TECHNICAL NEWS

[Issue No.] LVS-YE-0003[Page] 1/1[Title] Change in description methods for outline dimensions of main circuit terminals[Date of Issue] November 2020[Relevant Models] Air Circuit Breakers World Super series <Type : AE-SW/SWA>

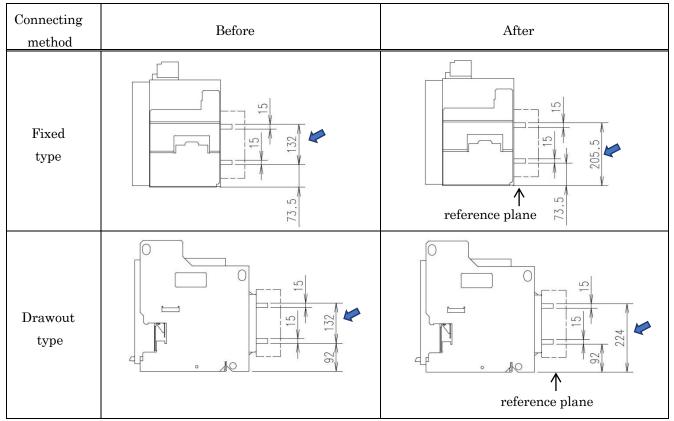
Change the description methods on main circuit terminals dimension from "the distance between terminals" to "the height of upper terminal from reference plane".

Above figures are on the side view of the horizontal terminal of AE630-SW, AE1000-SW, AE1250-SW, AE1600-SW.
